Request of Class II Permissive Change

Company name: Seeed Technology Co., Ltd FCC ID: Z4T-WM1303-A FCC Part 15 Certification

This is to request a Class II Permissive Change for FCC ID: **Z4T-WM1303-A** originally granted on

## (2) Add the PA substitute material

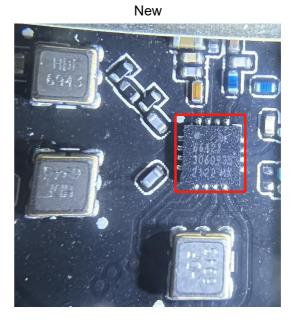
Original

(3) Changing a few parts of Layout Original

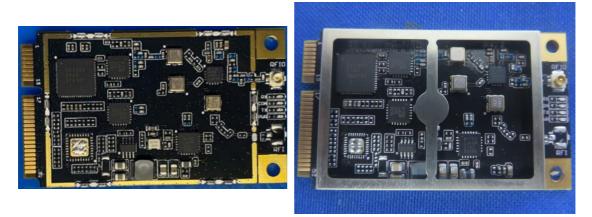
New
